GENERAL ELECTRIC IDENTIFIED THE STABILITY OPTION III PERIOD BASED DETECTION ALGORITHM T-min SPECIFICATION HAS A DEFECT

Subject: Reportable Condition Stability Option III: Period Based Algorithm

T_{min} Specification

Reference: NEDO-31960-A, BWR Owners' Group Long-Term Stability Solutions

Attachment 1 - Figure 1. Expected Oscillation Period vs. Core Flow

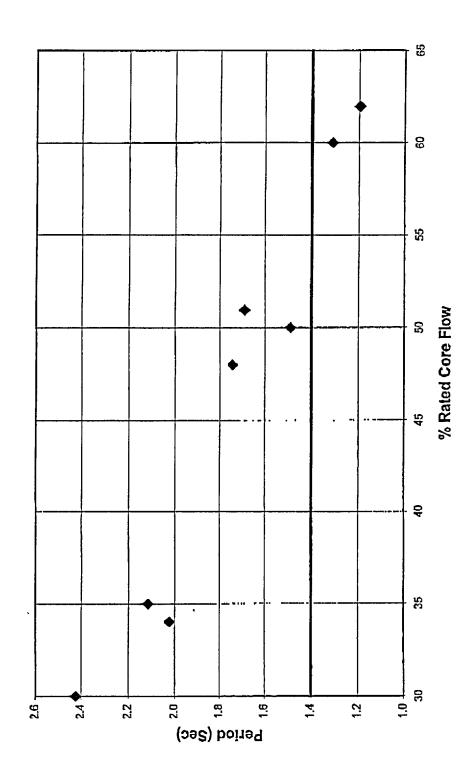
GE has performed calculations of oscillation period for different power/flow conditions with the GE frequency domain code ODYSY. Representative results from these calculations are shown in Figure 1 (attached). Calculations with other models and plant experience support these results.

The lowest value specified in the "typical" range for T_{max} is 3.0 seconds. The results in Figure 1 show that all periods are less than 3.0 seconds and that there is a significant margin between the nominal calculated periods to the 3.0 seconds value. Therefore, even if a plant uses the lowest "typical" value for T_{max} , it is expected to be greater than the actual period. Therefore, the "typical" range specified in T_{max} causes no safety concern.

The highest value in the specified allowable range for T_{min} is 1.4 seconds. The results in Figure 1 show that at high core flow, the expected oscillation period is below 1.4 seconds. The margin to T_{min} of 1.4 second is not adequate since the use of this "typical" T_{min} value could lead to failure of the PBDA to detect an expected oscillation. Failure of automatic detection at this condition is not expected to result in fuel failures, but may lead to violation of the Technical Specification MCPR safety limit. This is considered to be a Reportable Condition on NEDO-31960-A, Supplement 1. GE analysis shows that for current licensed operation conditions, a generic T_{min} value of 1.2 seconds provides adequate margin to expected oscillation periods.

- 1) Absent plant-specific justification of a higher value, the OPRM is not considered to be operable with a T_{min} value greater than 1.2 seconds; T_{min} should be set to 1.2 seconds or lower. With T_{min} set to 1.2 seconds or lower, the OPRM is considered to be operable. However, GE recommends that plants consider using a value of 1.0 second to provide additional margin to the expected period range.
- 2) The OPRM is considered operable for values of T_{max} set to 3.0 seconds or higher. However, absent plant-specific justification, GE recommends using a T_{max} value of 3.5 seconds or higher to provide additional margin to the expected period range.
- 3) A tighter T_{min}/T_{max} range may be justified based on plant-specific analysis and/or experience.

- Absent plant-specific justification of a higher value, T_{min} should be set to 1.2 seconds or lower. GE recommends that plants consider using a value of 1.0 second to provide additional margin to the expected period range.
